## **Staff Report**

Re: New Construction -PLNHLC2017-00330

#### NEW CONSTRUCTION - SINGLE FAMILY DWELLING

PROPERTY ADDRESS: 970 E 2nd Avenue

Site / Landscape Plan 1/4" = 1'-0"

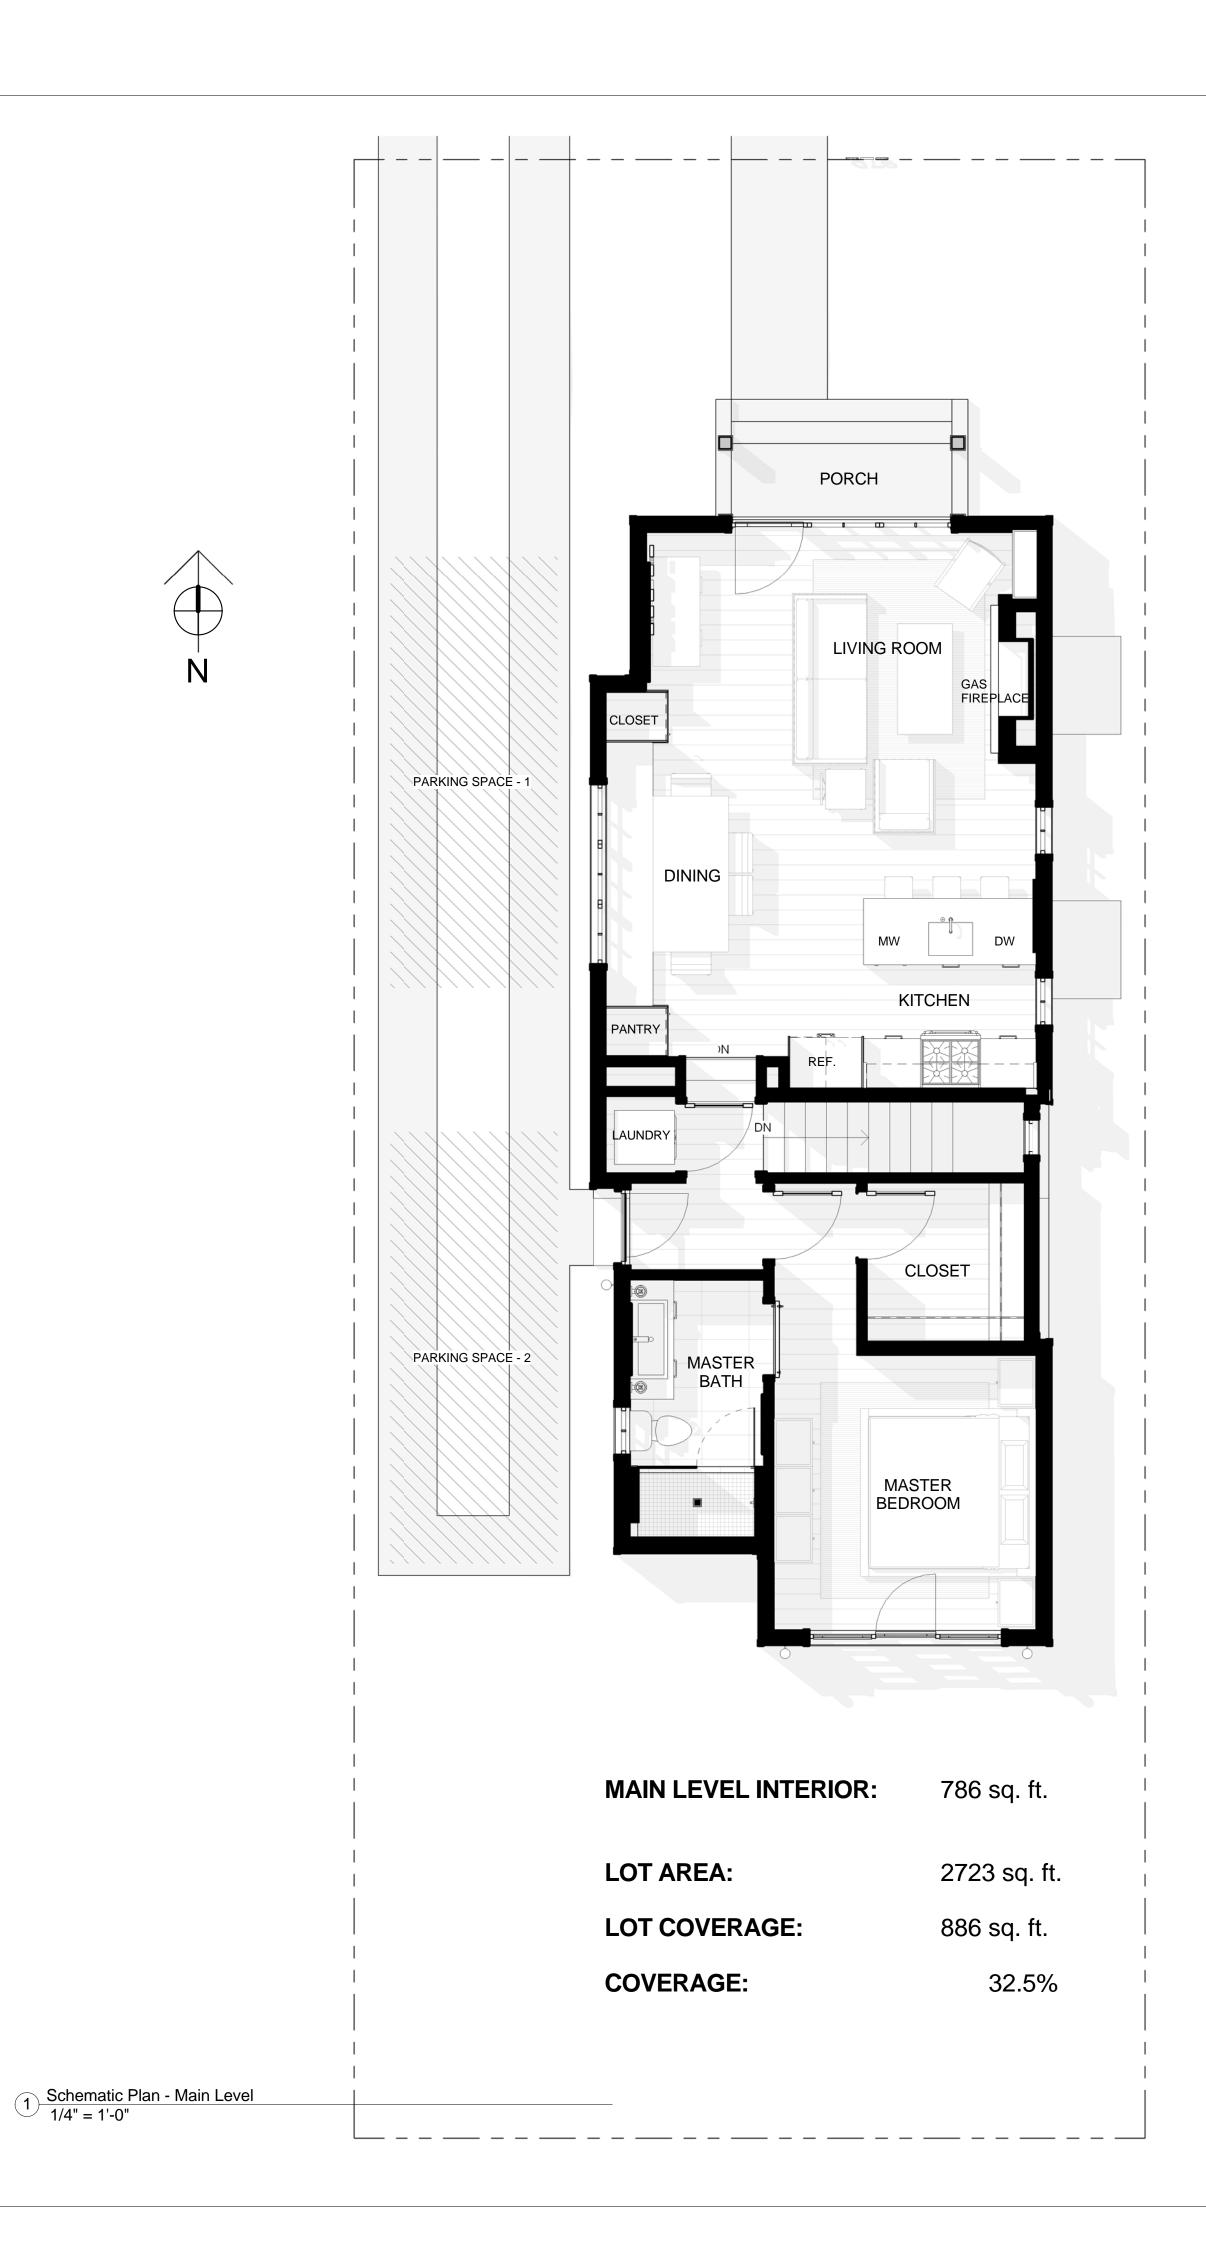
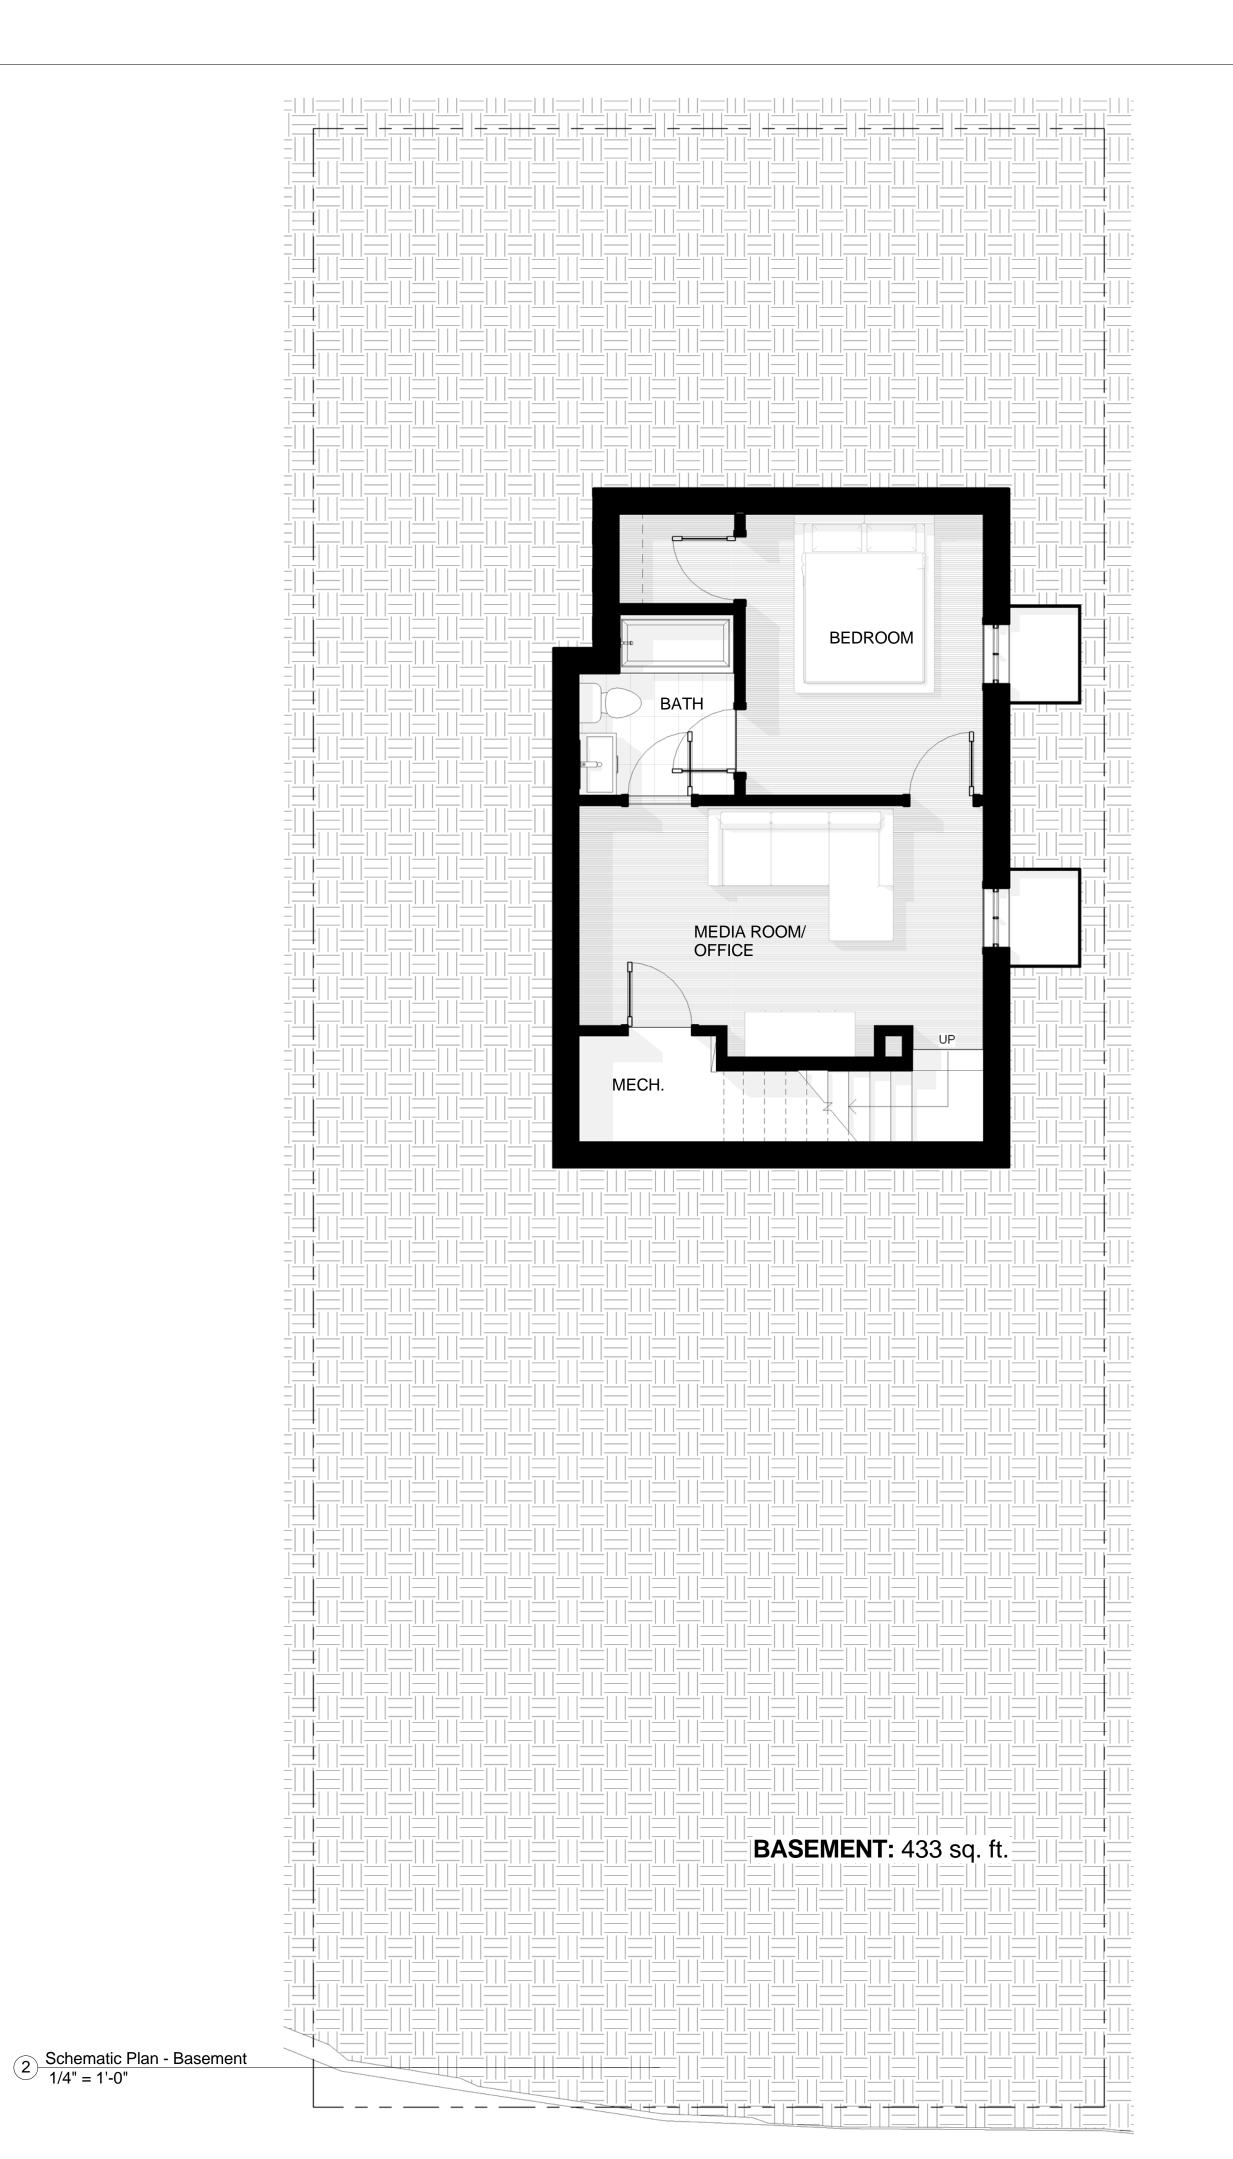
<u>Setback, front yard:</u> Site plan shows 10 foot front yard setback-- minimum front yard setback requirement to be met is per average of principal building locations of blockface (per 21A.24.080.E.1.b, including unique calculation for determining front average setback in the SR-1A district) or may be reviewed by HLC per S.E. application per 21A.06.050.C.6.g;

Setback, side yards: Site plan shows building extent at minimum required side yards of 4 and 10 feet;

<u>Setback, rear yard:</u> Site plan shows building rear extent of building at 20 foot deep rear yard—however, the 20 foot deep yard is less than minimum rear yard that is required (per 21A.24.080.E.4 is to be 25% depth of lot, which, in the case of subject lot that is 82.5 feet deep, the minimum rear yard requirement is 20 feet 7 ½ inches), to provide minimum required rear yard or may be reviewed by HLC per S.E. application per 21A.06.050.C.6.g;

Projections: Maximum 2 foot deep eaves may project into required yard of less than 20 feet per 21A.36.020(B), eave over man door of west façade might be exceeding;

<u>Driveway and Parking:</u> 12 foot wide driveway (21A.44.020.F.7.b) and minimum 6 foot setback of driveway from side property line (21A.44.020.F.7.a(2) are not shown on the site plan—would need to be approved by Transportation reviewer; tandem parking shown in site plan also a condition needing approval by Transportation reviewer;

Planning response to zoning comments: The proposal does meet the front yard setback requirements because there is only one other primary structure that fronts 2<sup>nd</sup> Avenue and the proposed construction is in line with that setback. In regards to the side yard setbacks, the SR-1A zoning district indicates that when the width of a lot is forty seven feet (47') or narrower, the total minimum side yard setbacks shall be equal to thirty percent (30%) of the lot width with one side being four feet (4') and the other side being thirty percent (30%) of the lot width minus four feet (4') rounded to the nearest whole number. The required side yard setbacks for the subject property are 6 FT on one side and 4 FT on the other, the proposal exceeds the required side yard setbacks. Following this review from building services, the applicant revised the plans to comply with the rear yard setback and the projection of awnings.
